Item ID: D3166-1 Accept ***N900040100*** Setup Start ***NS1***
Revision ID: Stop ***NS2***
Item Name: Basket Hoop
Start Date: 11/28/2016 Start Qty: 8.00 ***8*** Cust Item ID:
Required Date: 12/2/2016 Req'd Qty: 8.00 ***8*** Customer:
Reference:

DESIGN #	DRAWN BY CP	DART AEROSPACE LTD HAWKESBURY, ONTARIO, CANADA	
CHECKED #	APPROVED #	DRAWING NO. D3166	REV. A SHEET 1 OF 1
DATE 02.07.10	TITLE BASKET HOOP		SCALE NTS
A	02.07.10	NEW ISSUE	
A1	04.04.08	38+/-1 WAS 36.0

DRAWING NO. D3166	TITLE BASKET HOOP	REV A1	DART AEROSPACE LTD ENGINEERING ORDER		D.E.O. NO. D3166-A-2	SHEET NO. 1 OF 1	SCALE NTS
DRAWN AJS	CHECKED <i>[Signature]</i>	MFG. APPR. <i>[Signature]</i>	APPROVED <i>[Signature]</i>		DE APPR. <i>[Signature]</i>		
DATE 08.12.11	DATE 08.12.15	DATE 08/12/15	DATE 08/12/16		DATE 08.12.16

D3166-1 BASKET HOOP

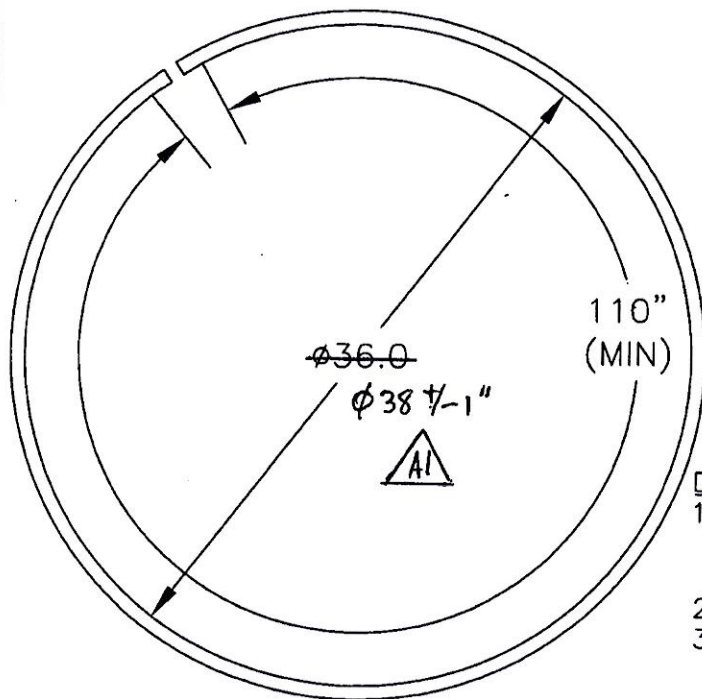
1) MODIFY MATERIAL NOTE FOR D3166-1 AS SHOWN:

WAS:

1) MATERIAL: AISI 304/316 SS SQUARE TUBING,
0.75" x 0.75" x 0.063 WALL, 60.00" LONG
(REF DART SPEC. M304TS0.750W.063)

2) MODIFY MATERIAL NOTE FOR D3166-3 AS SHOWN:

WAS:

1) MATERIAL: AISI 304/316 SS SQUARE TUBING,
0.75" x 0.75" x 0.063 WALL, 120.00" LONG
(REF DART SPEC. M304TS0.750W.063)

IS:

1) MATERIAL: AISI 304/316 SS, 3/4 X 3/4 X 0.065 WALL SQUARE TUBING,
60.00" LONG
REF. DART SPEC M304TS0.750W.065

IS:

1) MATERIAL: AISI 304/316 SS, 3/4 X 3/4 X 0.065 WALL SQUARE TUBING,
120.00" LONG
REF. DART SPEC M304TS0.750W.065
